**CALIFORNIA COASTAL COMMISSION**

**STAFF REPORT: REGULAR CALENDAR**

**APPLICATION NO.:** 5-01-199

**PROJECT LOCATION:** 3401 Ocean Blvd., City of Newport Beach, County of Orange

SITE PLAN  
SCALE 1/8" = 1'-0"

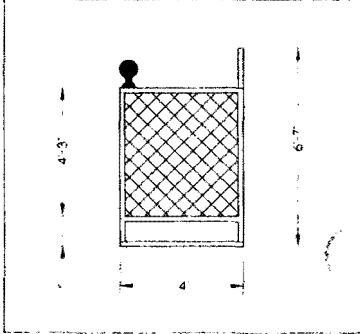
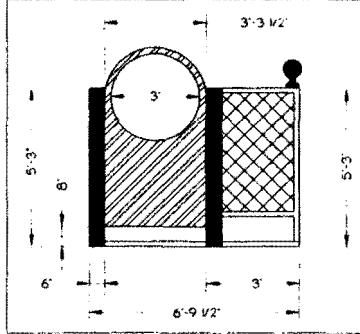
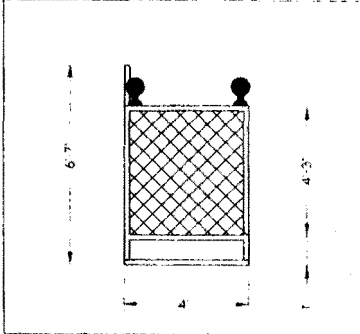
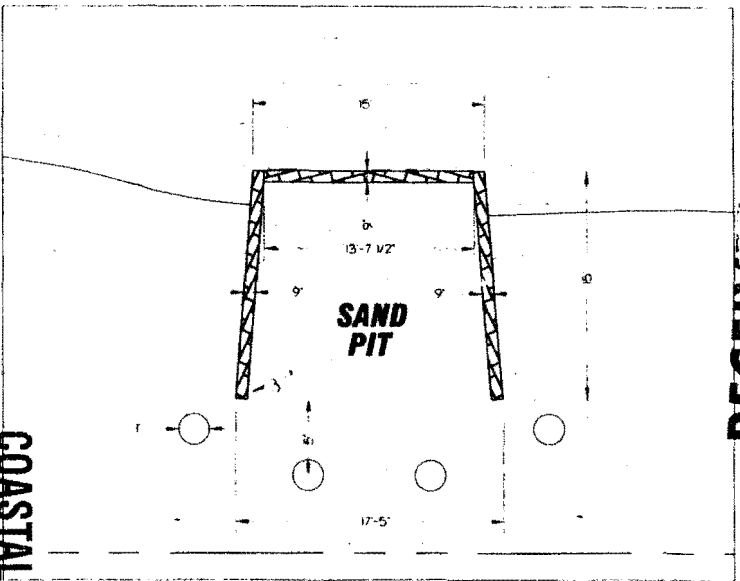
**PRIOR TO ISSUANCE OF THE COASTAL DEVELOPMENT PERMIT**, the applicant shall submit, in a form and content acceptable to the Executive Director, two (2) sets of revised project plans which show that the "sand pit" cut-out is deleted. The plans shall also show deletion of all improvements to the portion of the lower stairway landing not previously permitted, as generally depicted in Exhibit 3, page 2.

The applicant is requesting after-the-fact approval of a new "sand pit" cut-out at the toe of the slope and carry out aesthetic improvements to the existing stairway landings, including gate replacement and lattice panel installation. When the residence was approved in 1993, the Commission found that the *"structure is within the deck stringline and structural stringline, thereby protecting views from the public beach."* At that time, no new development or removal of vegetation was proposed along the toe of the bluff. However, between 1993 and the present, vegetation was removed along the base of the slope in order to establish the new retaining wall and rope enclosure. The proposed "sand pit" cut-out will affect public views of the vegetated bluff from the adjacent public beach, inconsistent with the pattern of development in the subject area. The Commission finds that the proposed sand pit cut-out does not minimize alteration natural landforms, is not visually compatible with the character of surrounding development and will affect the scenic and visual qualities of the subject area. As such, the portion of the proposed project involving the establishment of a sand pit cut-out area is inconsistent with Section 30251 of the Coastal Act.

As described previously, a portion of the applicant's proposal involves the construction of a sand pit cut-out at the toe of a vegetated bluff immediately adjacent to Corona del Mar State Beach (Exhibit 3). Due to its location next to a heavily utilized public recreation area, it is necessary to ensure that new development be sited and designed

Removal of existing vegetation along the base of the slope has occurred in order to construct the proposed retaining wall and rope enclosure. Although the vegetation is largely non-native groundcover (including iceplant), the bluff face appears natural and undeveloped. The proposed sand pit cut-out will affect public views of the vegetated bluff from the adjacent public beach, inconsistent with the current pattern of development. In addition, the proposed cut-out will result in alteration of the natural landform. As such, the portion of the proposed project involving the establishment of a sand pit cut-out area is inconsistent with Section 30251 of the Coastal Act. Therefore, the Commission denies the sand pit cut-out to protect views of the bluff from the beach and along the shoreline and to minimize landform alteration.

The Commission finds the portion of the project consisting of the sand pit cut-out to be inconsistent with the scenic resources policies of the Coastal Act, as more fully described in Section IV.C, Denial Findings and Declarations. To protect the scenic and visual qualities of the coastal bluff at the location, the Commission imposes Special Conditions 1 and 2. Special Condition No. 1 requires the applicant to submit revised project plans showing that the proposed sand pit cut-out at the base of the bluff has

been deleted and that the portions of the lattice work on the landing area previously unpermitted have been deleted, as shown in Exhibit 3, page 2. Spécial Condition No. 2 is a future development deed restriction which states that any future improvements or additions on the property, including hardscape improvements, grading, landscaping, vegetation removal and structural improvements, require a coastal development permit or amendment to this permit from the Commission or its successor agency. This condition ensures that development on the coastal bluff which may affect the stability or appearance of the bluff or may contribute to an adverse cumulative effect on community character, require a coastal development permit.

PAGE 2 OF 2

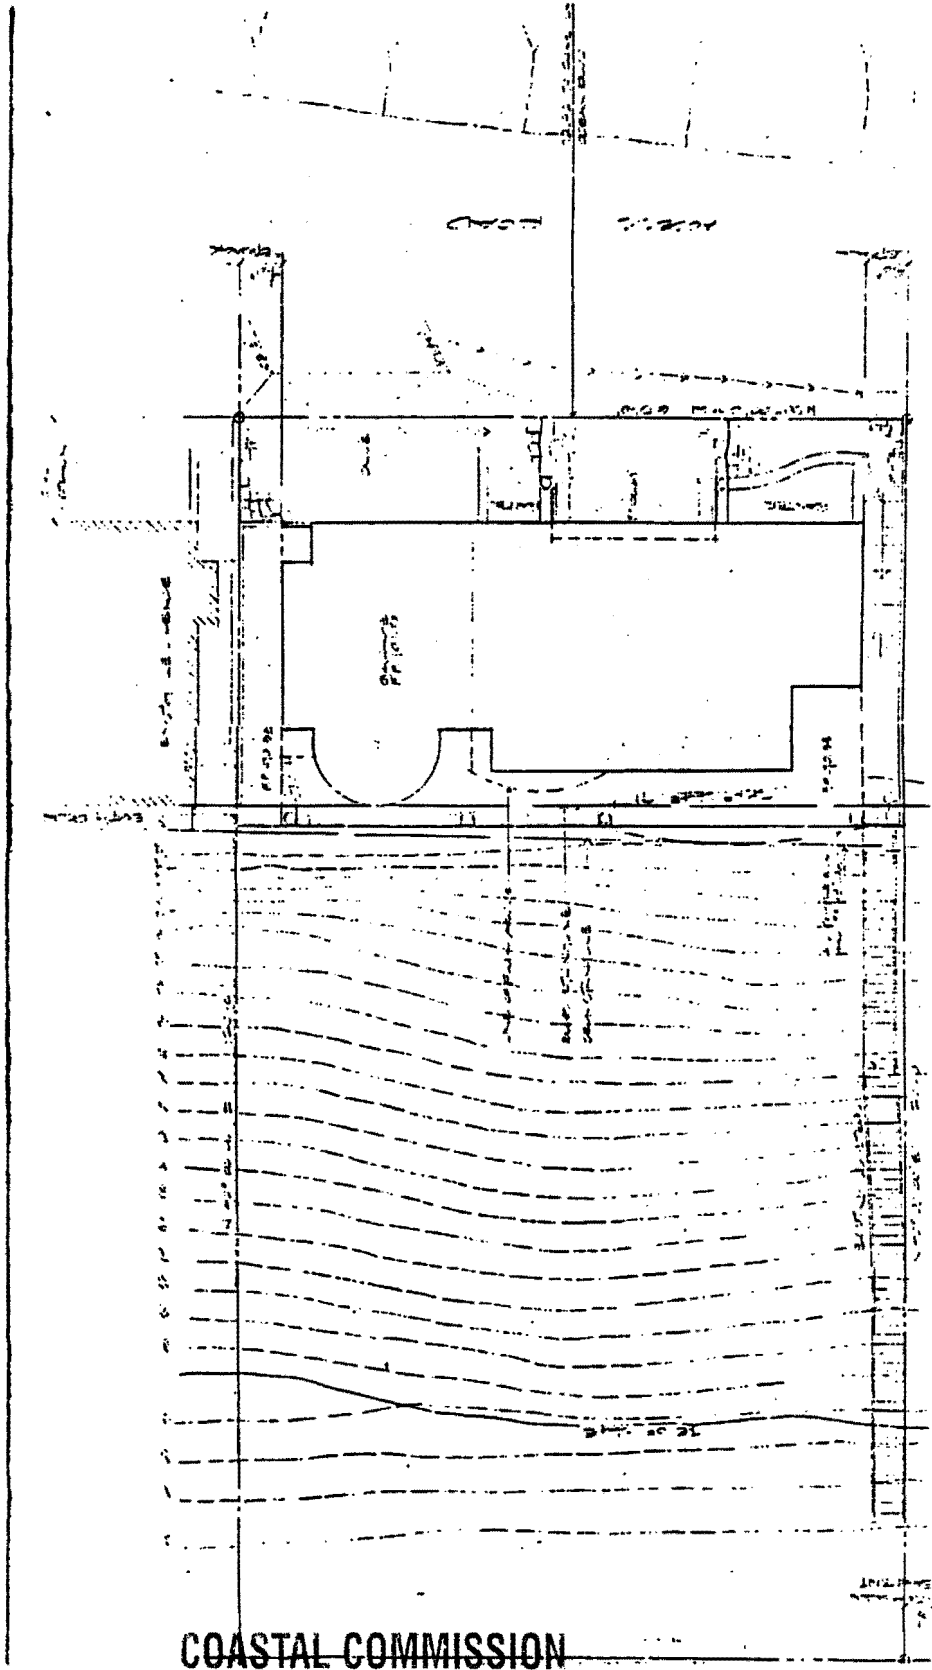
Existing development  
as recognized  
by 5-93-030

Unpermitted  
development

Unpermitted  
development
